Re: FCC ID EFOIC-F1020WN-2

Applicant: Tactical Electronics
Corporation

Correspondence Reference Number: 23586
731 Confirmation Number: EA344968

Front Panel

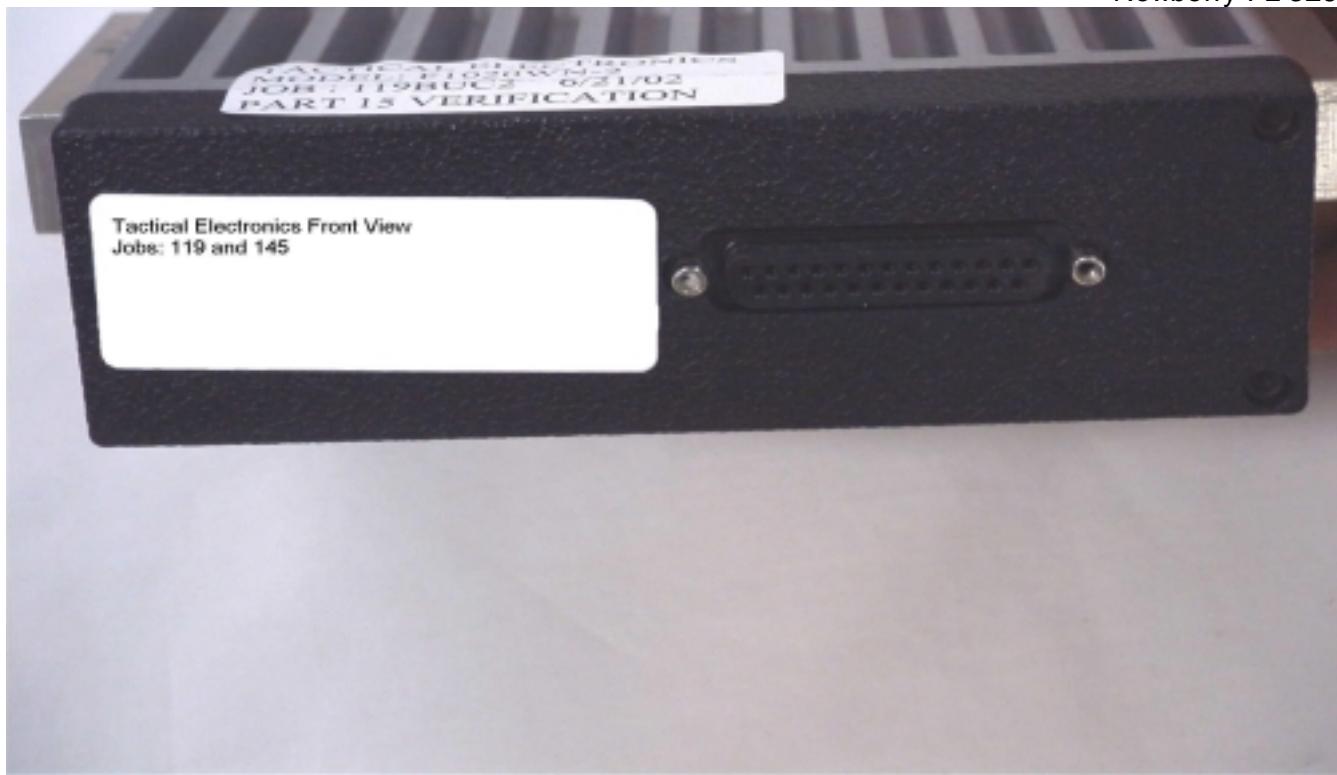
1.) Correspondence 23521. Your response is incorrect. You have sent the same information for EA134249. It appears that you have cut and paste this information for both applications. Your MPE calculation states a duty factor of 0.067 percent, not 0.167 percent. You have submitted the same FCC ID number and the same EA number for EA134249. Please submit the correct changes for EA344968 and submit a new correspondence.

1.) This appears to be a Push-to-Talk device with a 50% duty factor. Your MPE calculation states a duty factor of 0.067 percent on time. Please explain.

Thanks for your email. You are correct and the email sent to you was inadvertently copied and pasted.

The F1020WN-2 (VHF) radio is a data only transceiver and has no PTT or microphone connector. The MPE calculation was written with the following: An uncontrolled population exposure of 2 minutes in 30 minutes. The applicant suggested this would be a reasonable exposure period for this radio's application. Enclosed also find a front panel photograph of the radio which hopefully shows a better view of the DB-25 connector on the front.
